Your ref
BN/52/19/HH

Our ref
PLAN-029306

Proposal: Ground and first floor rear extension and alterations.
Site: BN/52/19/HH: - Brook Cottage, Lake Lane, Barnham PO22 0AD.

Southern Water MapGuide Browser

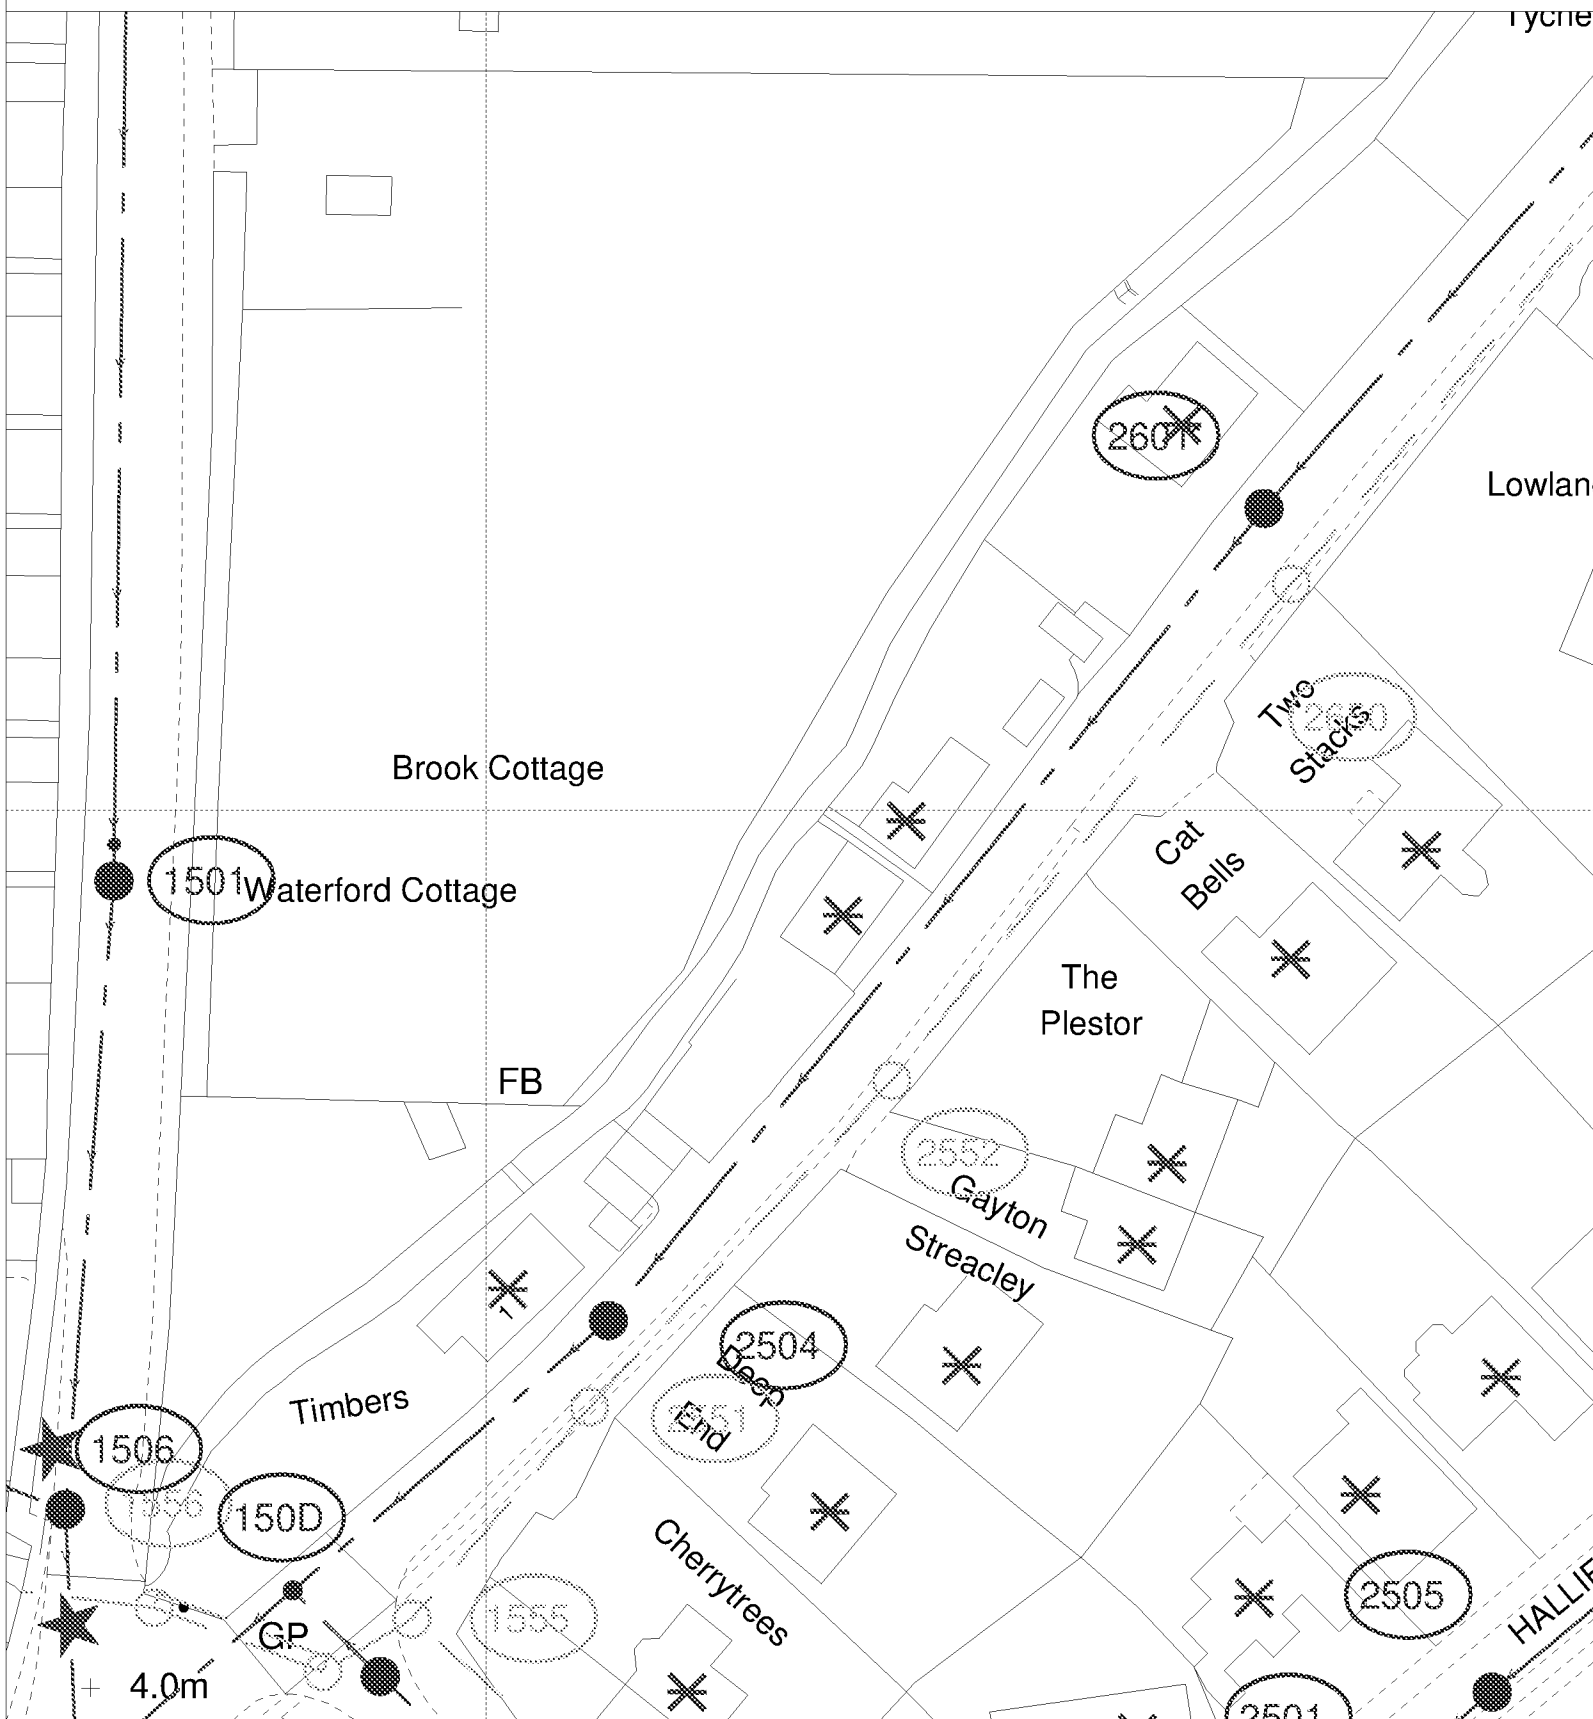
It is possible that a sewer now deemed to be public could be crossing the development site. Therefore, should any sewer be found during construction works, an investigation of the sewer will be required to ascertain its ownership before any further works commence on site.
